BULLETIN NO. 4
on

Project No. GESA 2017-1 – REQUEST FOR QUOTES FOR A GUARANTEED ENERGY SAVINGS PROJECT AT: DEPT. OF GENERAL SERVICES, CAPITOL COMPLEX, HARRISBURG, PENNSYLVANIA, Department of General Services, Energy & Resource Management, 401 North Street, Room 403, Harrisburg, Pennsylvania, 17120.

REQUEST FOR INFORMATION (DGS Responses in bold text)

FLOOD & STERLING, INC.
DATA SHEET

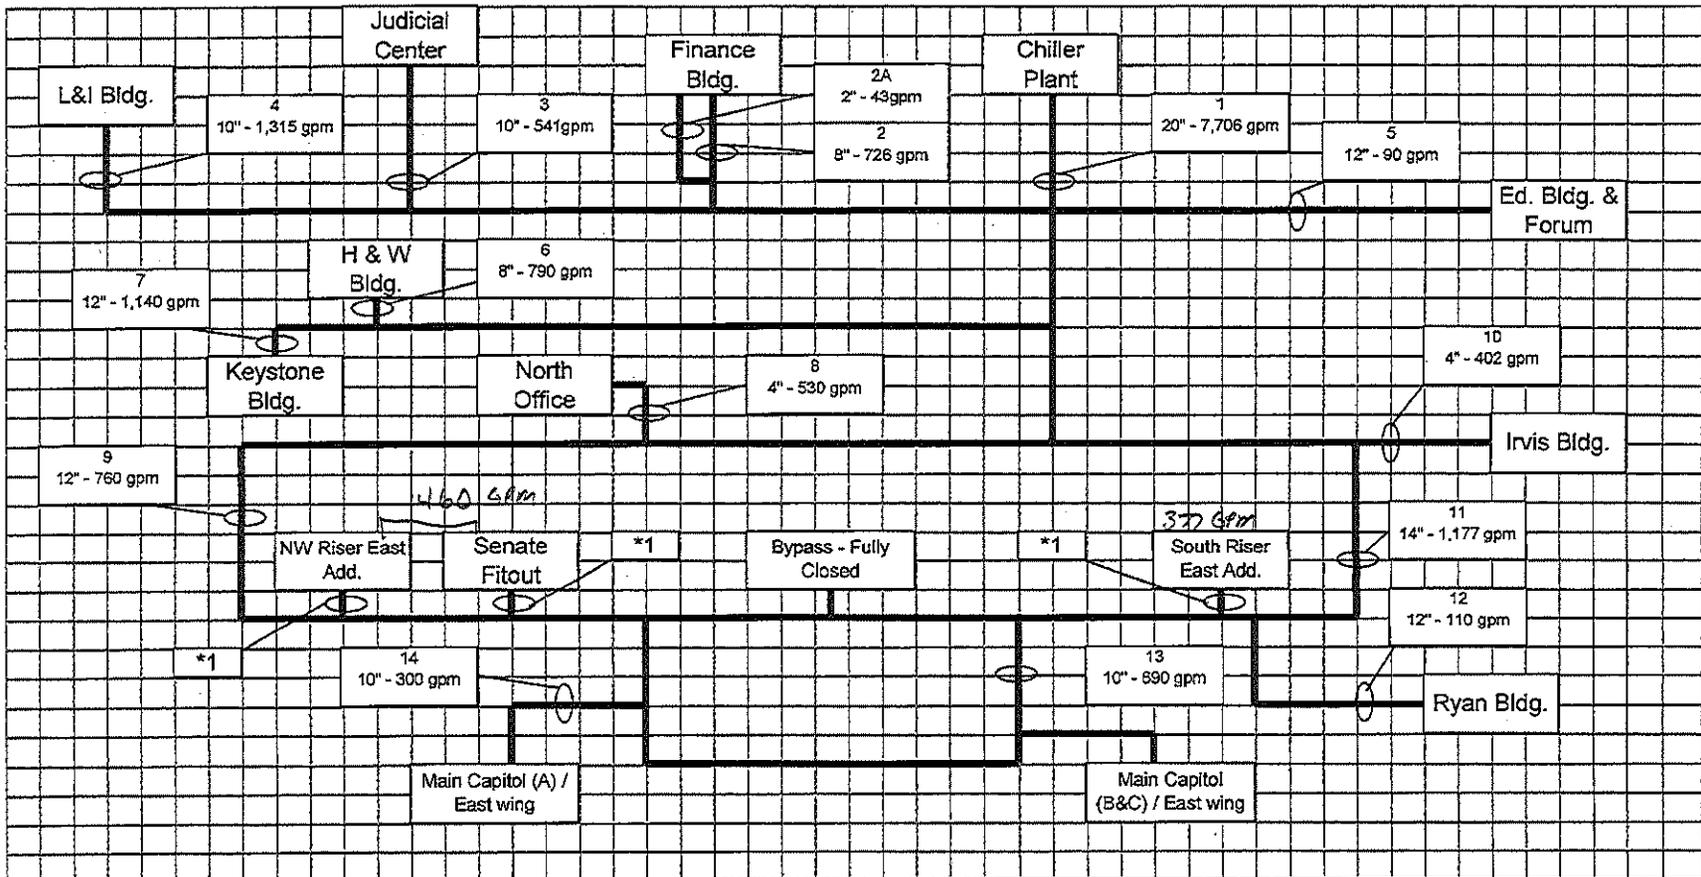
5. The scope-of-work includes core ECMs that must be evaluated as part of the response. ECM 2 relates to delta T management of the chilled water distribution loop and loop flow controls. However, the central plant also serves buildings with chilled water distribution systems that are not included in the RFP scope. Any comprehensive solution to improving efficiency here would more than likely also involve modifications to the distribution systems of buildings that are not currently included within the RFP scope. Should ESCOs limit proposed work to buildings solely within the current RFP scope even though this will likely be limiting to the potential success of this measure?

Answer: This Measure will include more buildings than the listed buildings. The main system used to be a primary secondary system to each building. A project +/- 2006 was done and placed VFD on the main chiller plant pumps, added bypasses to the secondary pumps and replaced the 3-way valve with 2-way valves. In the PJC, there is a heat exchanger with building side pumps. In the Keystone building, there are 22 AHUs - 18 are used in 6 (2 primary, 1 backup systems), 2 are dedicated out door air systems and 2 feed the atrium. Please see attached chart for the remaining buildings. For the building flow summary from previous flow study, see attached sheets.
